Access Compliance Report

Public Rights-of-Way

(Curb Ramps)

Intersection ID: 15201	Main Street: ALBEMARLE_RD	Cross Street: LAWYERS_RD	Location: NE
ADA ID: E77EB1F14B7E	Ramp Type: Perp	Initial Pass/Fail: Fail	Overall Compliance: No
Severity Score: 8.75			
Codes/Mitigation Info/Possible Solution		Field Measurements/Component Compliance

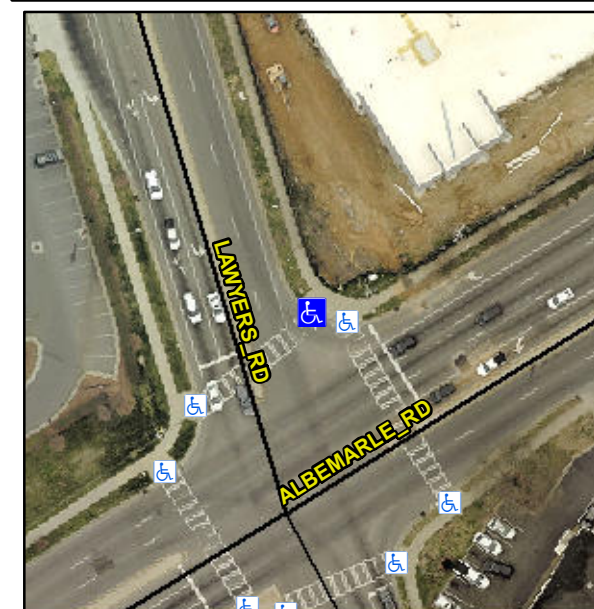
Compliance	Description	Data	Compliance	Description	Data
N/A	Ramp Length (in)	94.0	Yes	Ramp Slope (%)	5.6
No	Ramp Width (in)	47.0	Yes	Ramp XSlope (%)	0.2
N/A	Flare Type LT	N/A	N/A	Flare Type RT	N/A
N/A	Flare Slope LT (%)	N/A	N/A	Flare Slope RT (%)	N/A
N/A	Flare Traversable LT?	N/A	N/A	Flare Traversable RT?	N/A
N/A	Landing Length (in)	N/A	N/A	DWS Provided?	N/A
N/A	Landing Width (in)	N/A	N/A	DWS Contrast?	N/A
N/A	Landing Slope (%)	N/A	N/A	DWS Length (in)	N/A
N/A	Landing X Slope (%)	N/A	N/A	DWS Full Width?	N/A
N/A	Landing Curb? (Y/N)	N/A	N/A	DWS Offset (in)	N/A
N/A	Shared Landing?	N/A			
N/A	Gutter Ponding?	N/A	N/A	Gutter Slope (%)	N/A
N/A	Gutter Lip Ht (in)	N/A	N/A	Gutter X Slope (%)	N/A
N/A	Painted X Walk1?	Yes	N/A	Painted X Walk2?	N/A
	X Walk 1 Direction	To SW		X Walk 2 Direction	N/A
N/A	X Walk 1 Width (in)	122.0	N/A	X Walk 2 Width (in)	N/A
	X Walk 1 Slope (%)	2.5		X Walk 2 Slope (%)	N/A
	X Walk 1 X Slope (%)	2.7		X Walk 2 X Slope (%)	N/A

N/A	Ramp inside XWalk1?	Yes	N/A	Ramp inside XWalk2?	N/A
	Road Slope (%)	N/A	N/A	Clear Space?	N/A
	Road X Slope (%)	N/A	N/A	Clear Space to XWalk (in)	N/A
N/A	Any Obstructions?	N/A	N/A	Storm Grate/Utility Hazard?	N/A
	Obstruction Type			Storm Grate/Utility Type	
		N/A			N/A
			Yes	Surface Condition? (G/P)	Good

Remove & Replace Entire Ramp.
